A d d e n d u m

Iowa Department of Transportation
Office of Contracts

B.O.	Proposal ID	Proposal Work Type	County	Project Number	Addendum
106	40-0204-049	PCC Pavement - Grade & Replace	Hamilton	NHSX-020-4(49)--3H-40	19jun106.a02

Make the following change to the Plan Sheet C.1:

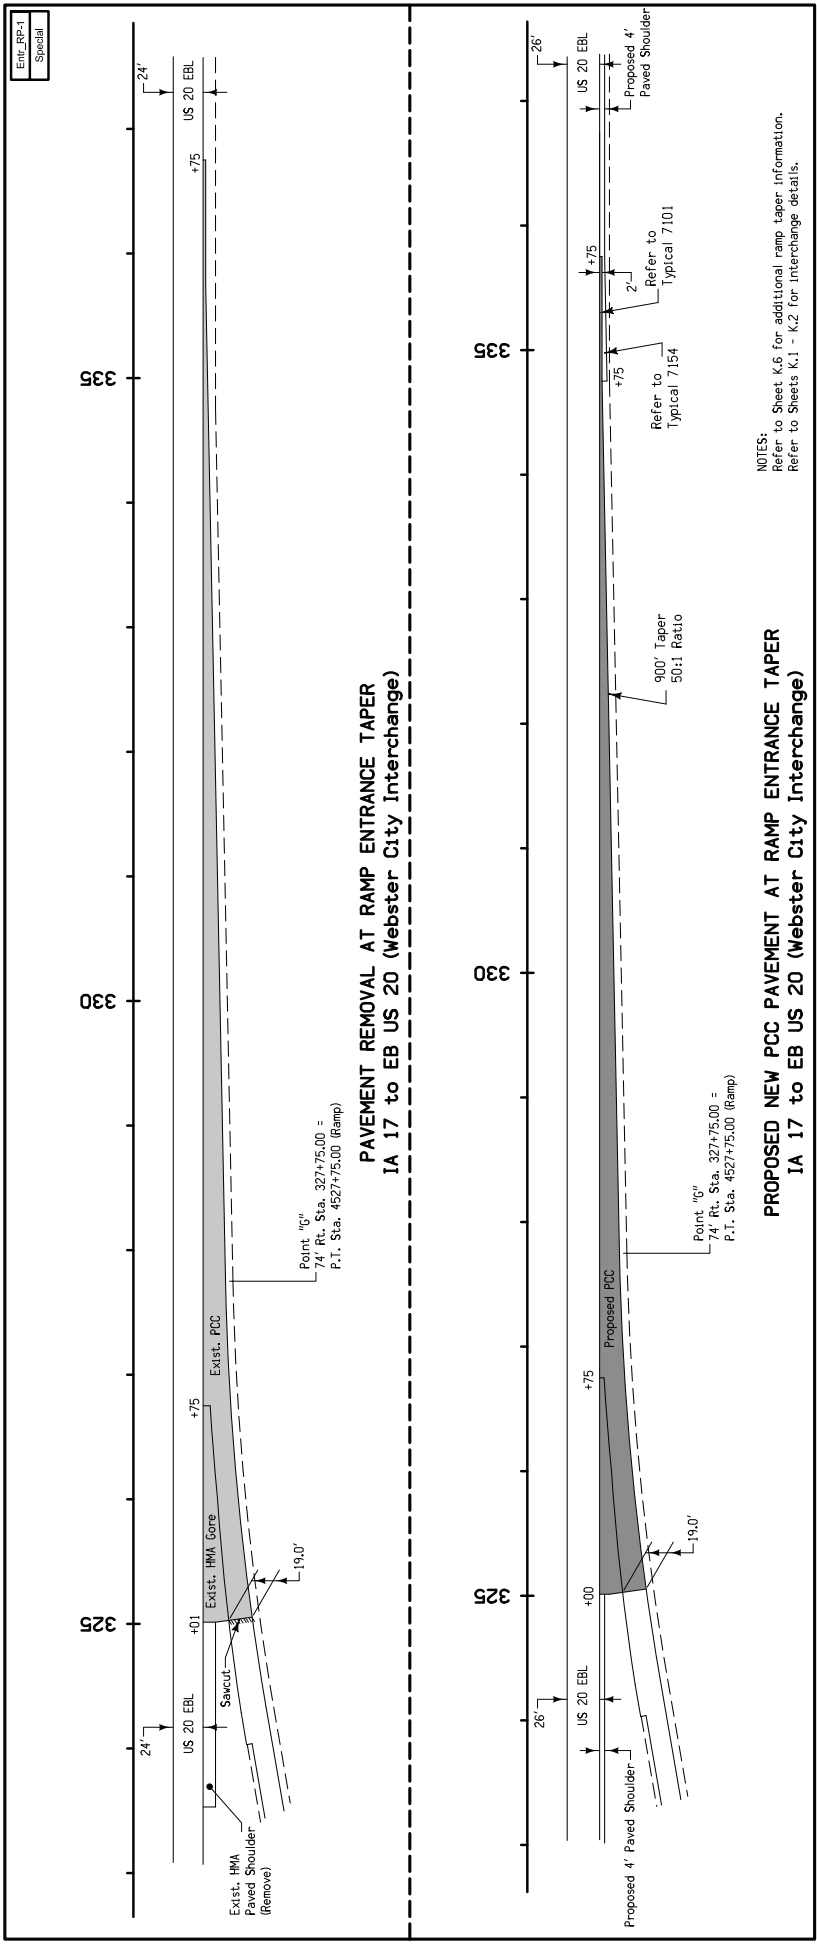
Tabulation for ESTIMATED PROJECT QUANTITIES:

ITEM	UNITS	DIV. 1	DIV. 2	TOTAL
Replace:	Special Backfill	CY	10,710.0	57,495.0	68,205
With:	Special Backfill	CY	10,791.0	57,563.0	68,354
Replace:	Granular Subbase	CY	27,600.0	140,196.0	167,796
With:	Granular Subbase	CY	27,600.0	140,400.0	168,242
Replace:	Std/S-F PCC Pav't, QM-C, Cl 3, 10.5 in.	SY	22,262.0	110,979.0	133,241
With:	Std/S-F PCC Pav't, QM-C, Cl 3, 10.5 in	SY	22,262.0	111,183.0	133,445
Replace:	Quality Management Concrete	CY	6,493.0	32,369.0	38,862
With:	Quality Management Concrete	CY	6,493.0	32,428.0	38,921

ENTR-PR-1
Special

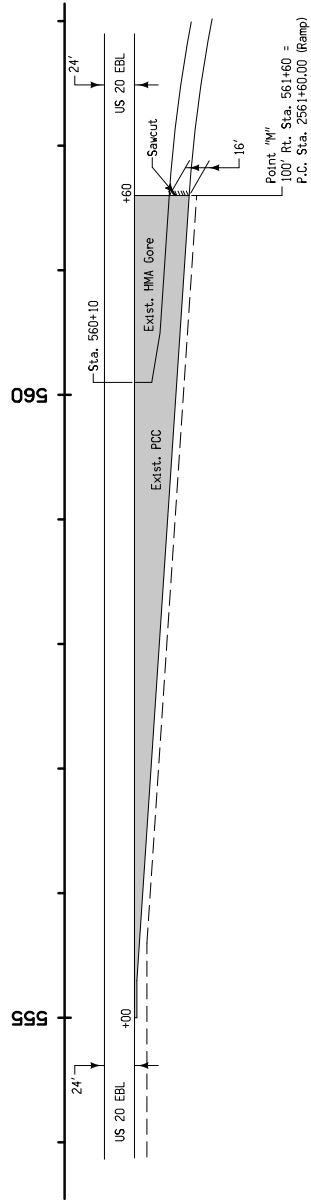
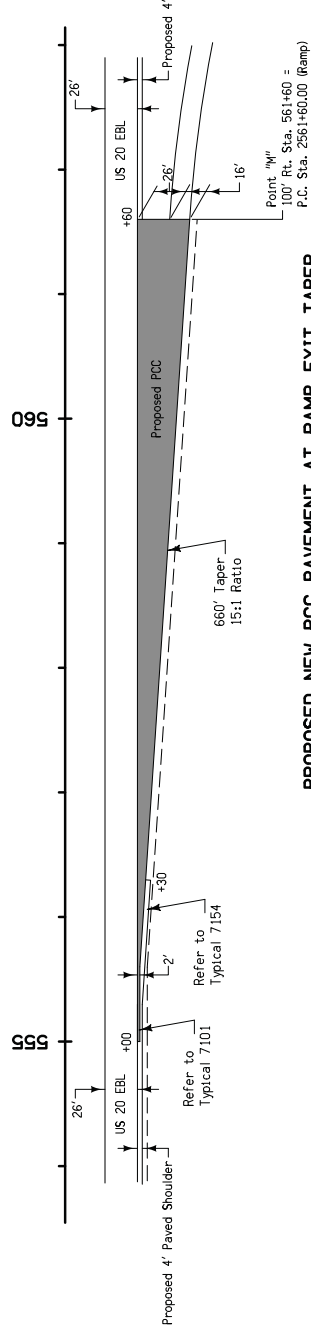
Make the following change to the Plan Sheet B.2:

Replace Typical Entr_RP-1 Special with the attached Typical Entr_RP-1 Special.

PROPOSED NEW PCC PAVEMENT AT RAMP EXIT TAPER
EB US 20 to Co. Rd. R38 (Kamrar Interchange)

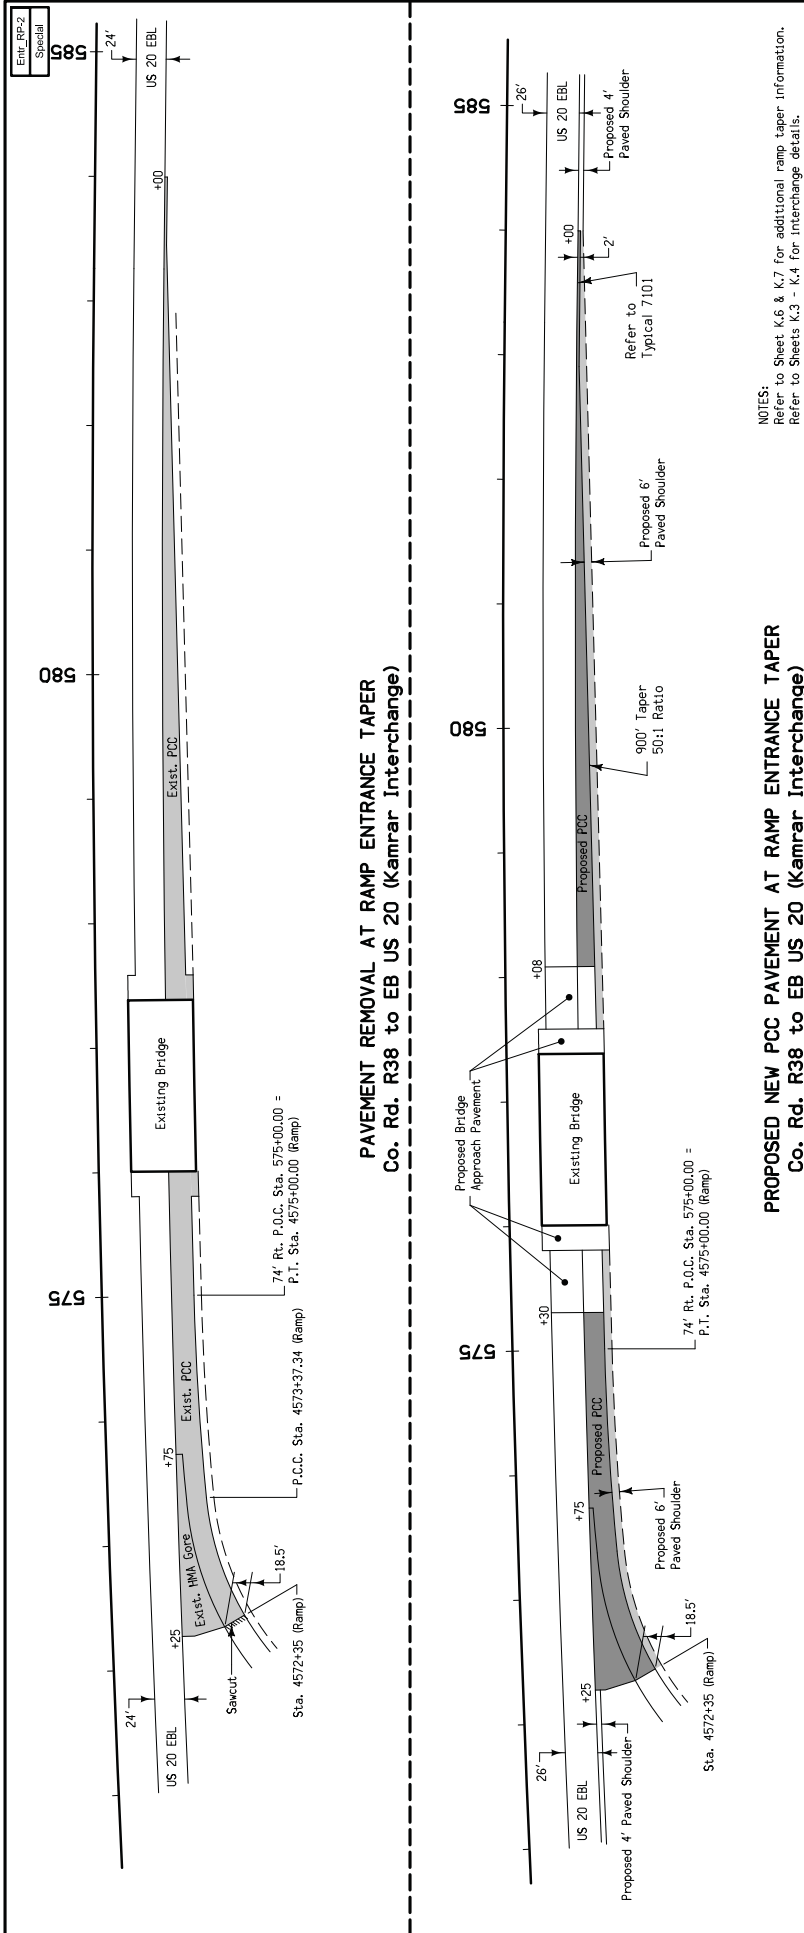
Make the following change to the Plan Sheet B.3:

Replace Typical Exit_RP-1 Special with the attached Typical Exit_RP-1 Special.
